THE RESERVES at EAGLE POINT

405 NORTH PICADILLY RD - BUILDING D

City of Aurora Building Division
Project: ***The Reserves at Eagle Point BLD D***
Address: ***405 N PICADILLY RD***
Occupancy Group: ***R2***
Construction Type: ***VB-SPK***
RSN: ***1762362***
Permit: ***2023 2396776-LT***

City of Aurora Building Division
Reviewed for Code Compliance
Approved as Noted: Kirk Nagle
Date: **Feb 12, 2024**
2021 INTERNATIONAL CODES & 2023 NEC

A **APARTMENT BUILDINGS D/E/G/H (TYPE 1) ROOF PLAN**
1/8"=1'-0"

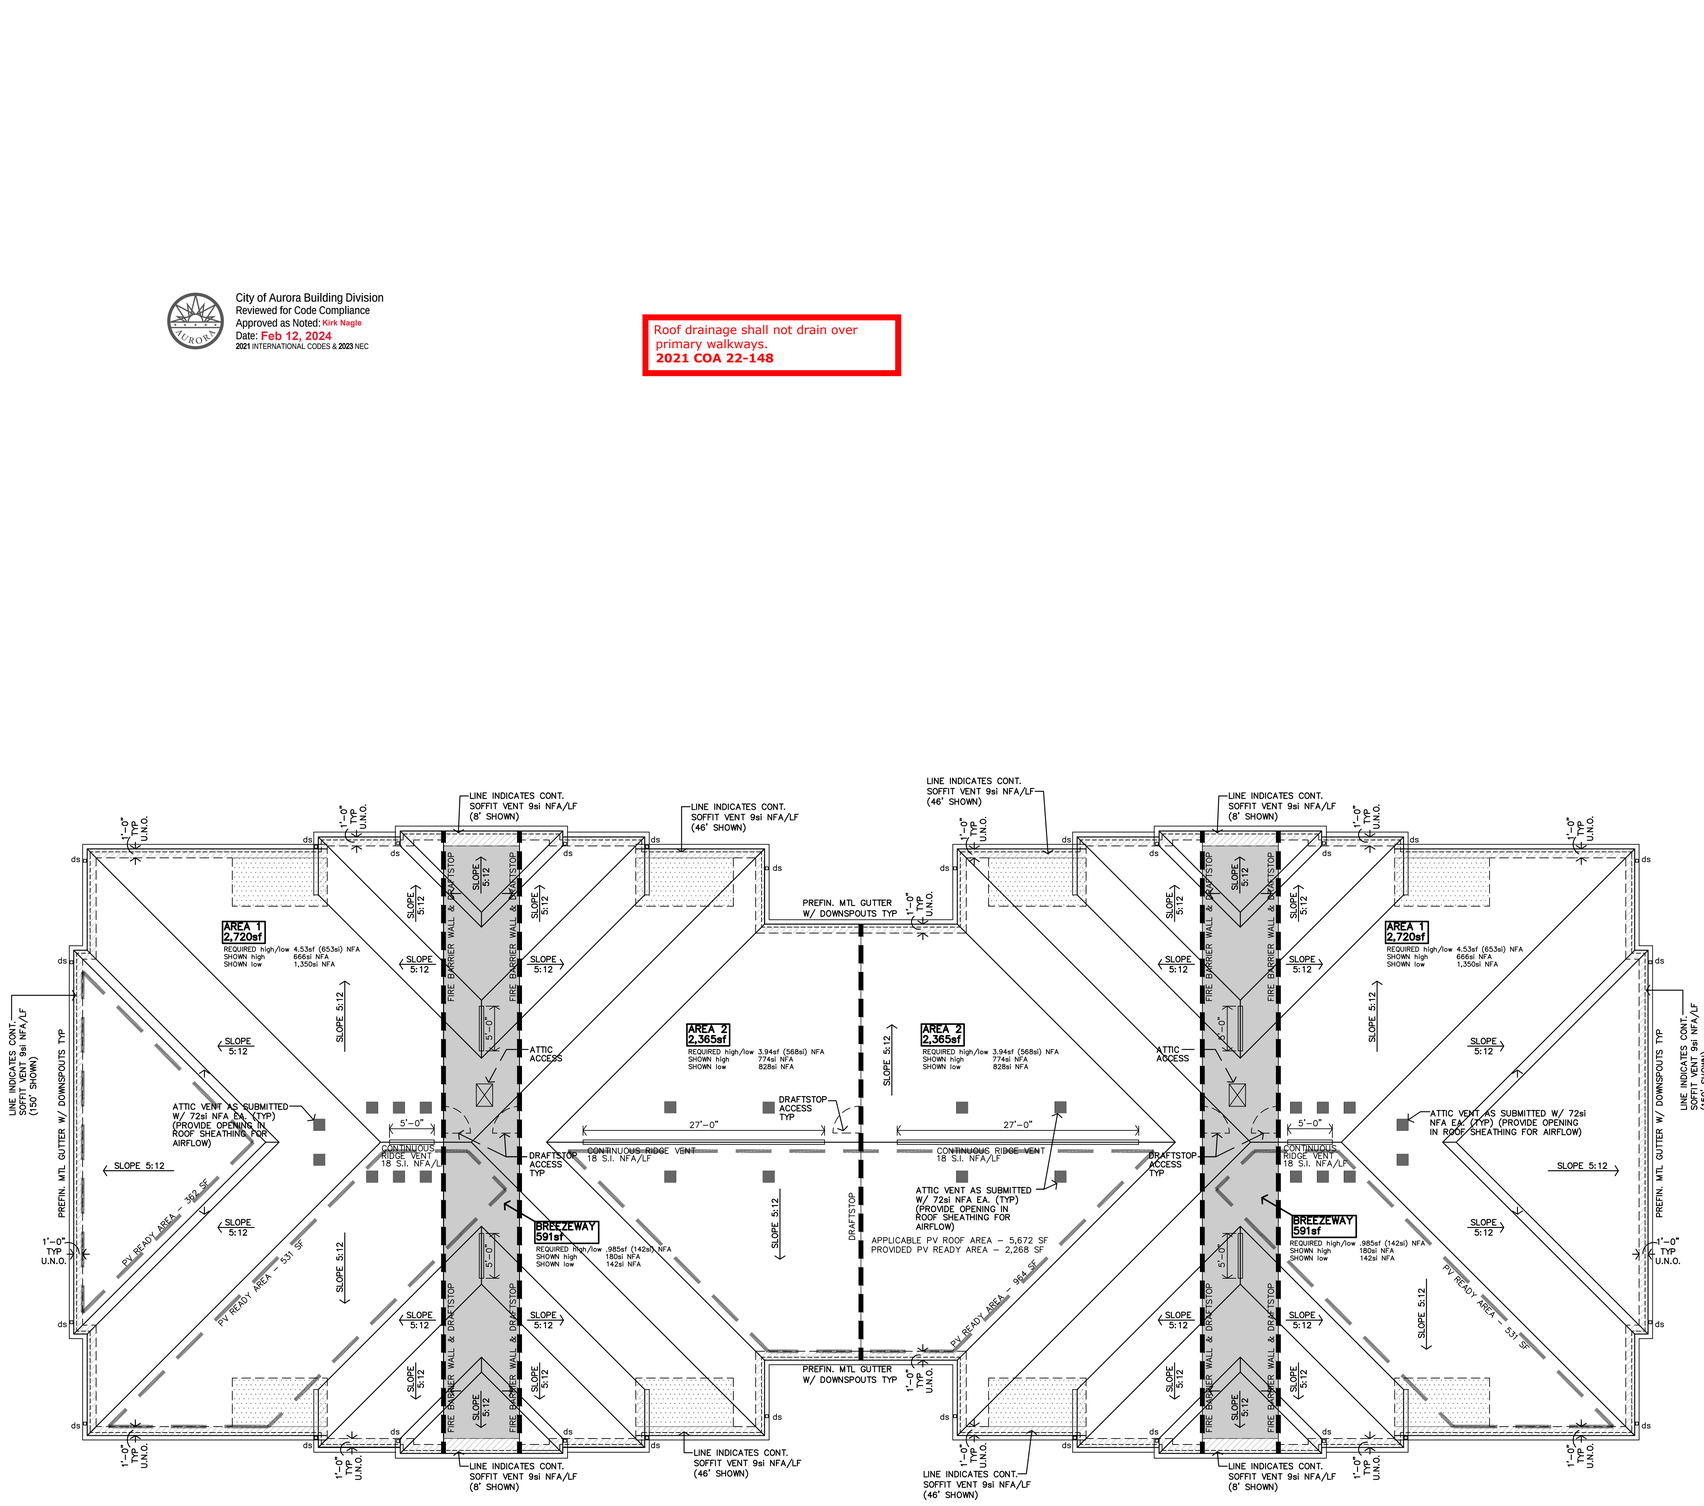
Roof drainage shall not drain over primary walkways.
2021 COA 22-148

1 APARTMENT BUILDING TYPE 1 FIRST FLOOR M/E PLAN (D, E, G, H)
1/8" = 1'-0"

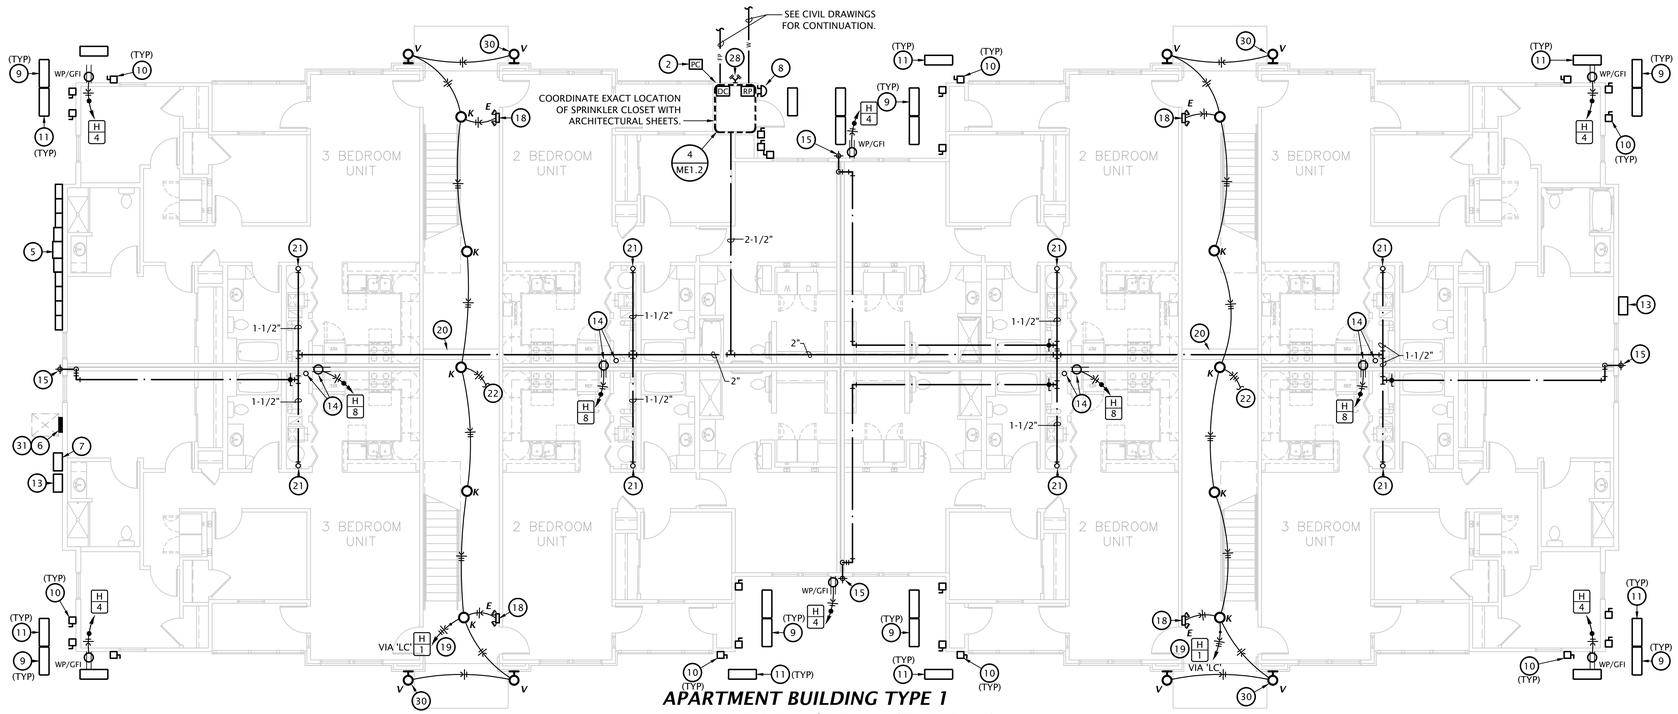
Install required lighting outlets for dwelling units per 2023 NEC 210.70(A)(B)(C).

3 ACCESSIBLE 3 BEDROOM POWER PLAN
1/4" = 1'-0"

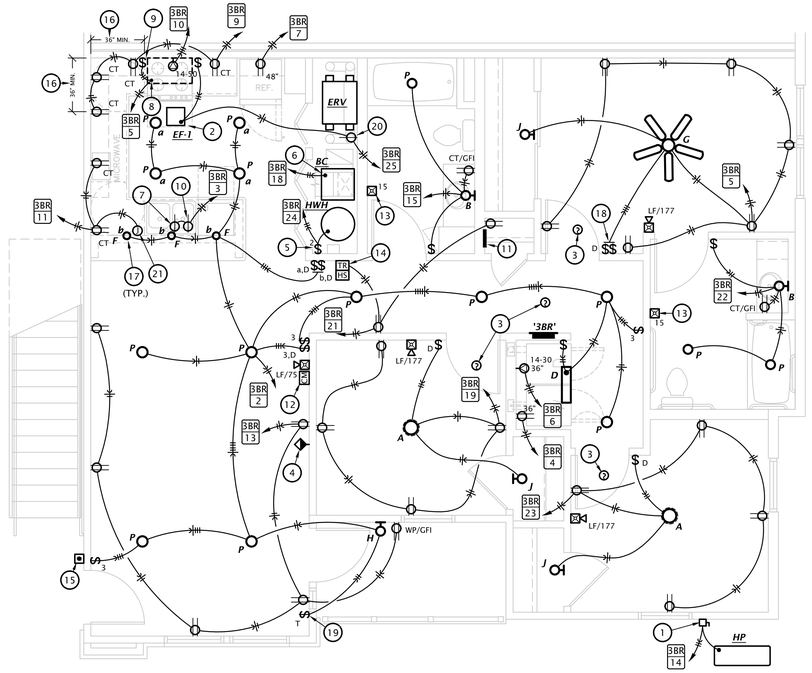
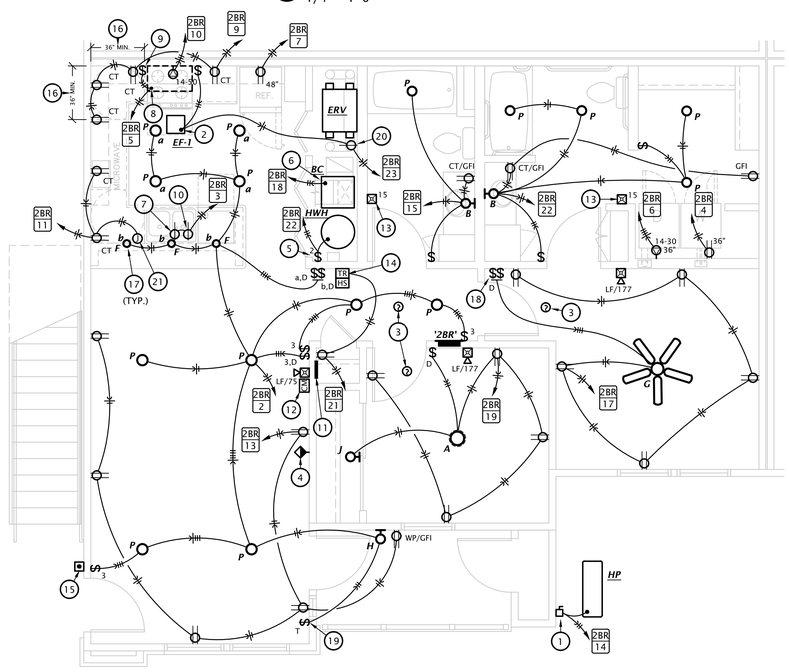
Every circuit and circuit modification shall be provided with a legible and permanent description that complies with all of the following conditions as applicable (see 1-6). 2023 NEC 408.4

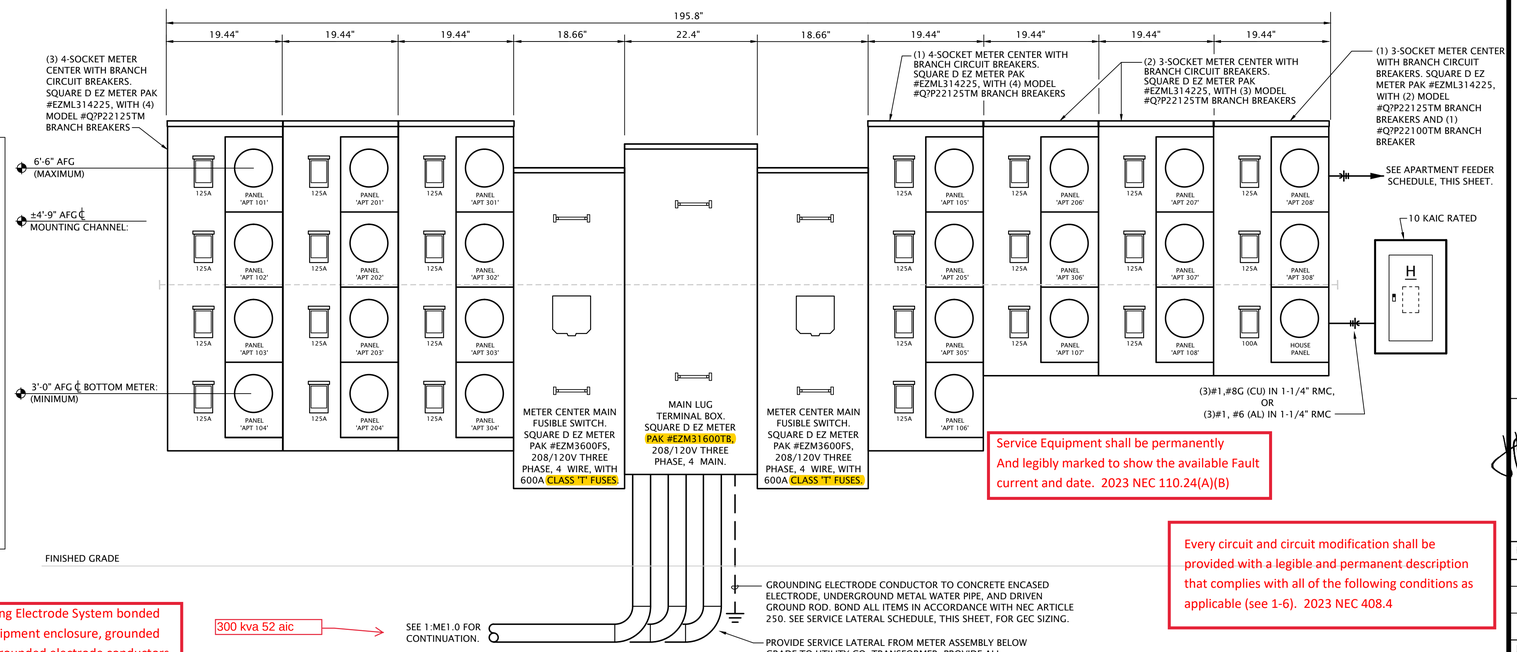
Coordinate final location of meter assemblies with utility company. Provide shop drawings of proposed equipment whether as specified or substituted to utility company for approval.
- All meter center components shall be NEMA 3R
- All dimensions based on Square D equipment, it is the contractor's responsibility to verify the dimensions of substitute equipment and receive approval from utility for substitution.
- For each meter, provide a permanent brass, copper or aluminum tag identifying the apartment served. Tags shall be securely fastened to the meter base and be stamped with 1/8" letters, minimum.

Service Equipment shall be permanently And legibly marked to show the available Fault current and date. 2023 NEC 110.24(A)(B)
